CHANGE REQUEST		Please see embedded help file at the bottom of this page for instructions on how to fill in this form correctly.	
33.102 CR 088rev1		Current Version: 3.4.0	
GSM (AA.BB) or 3G (AA.BBB) specification number ↑		↑ CR number as allocated by MCC support team	
For submission to: SA#8	for approval <input checked="" type="checkbox"/>	strategic <input type="checkbox"/>	(for SMG use only)
list expected approval meeting # here ↑	for information <input type="checkbox"/>	non-strategic <input type="checkbox"/>

Source: TSG SA WG3 **Date:** 19 Mai 2000

Subject: Initialisation of synchronisation for ciphering and integrity protection

Figure 16c: The structure of COUNT-C for all transmission modes

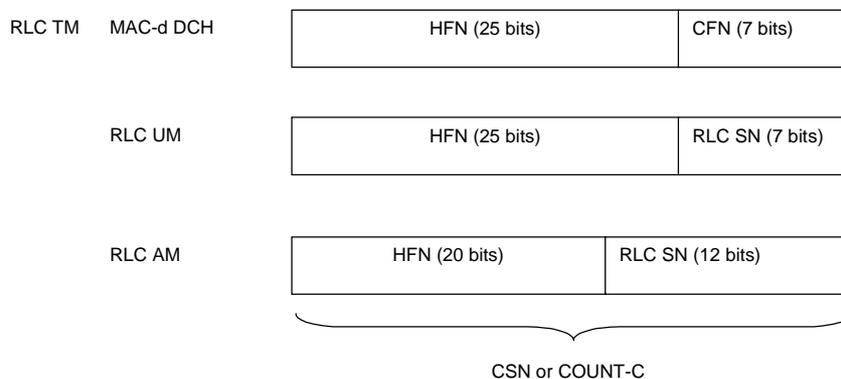
The hyperframe number HFN is initialised by means of the parameter START, which is transmitted from UEME to RNC in RRC connection establishment. The UEME and the RNC then initialise the X₂₀ most significant bits of the RLC HFN and MAC HFN to START; the remaining LSB-bits of the RLC HFN and MAC HFN are initialised to 0. The RRC HFN are incremented independently for each logical channel.

~~Editor's note: The value of X still needs to be decided.~~

~~Editor's note: The description of how START is managed in the UE needs to be added.~~
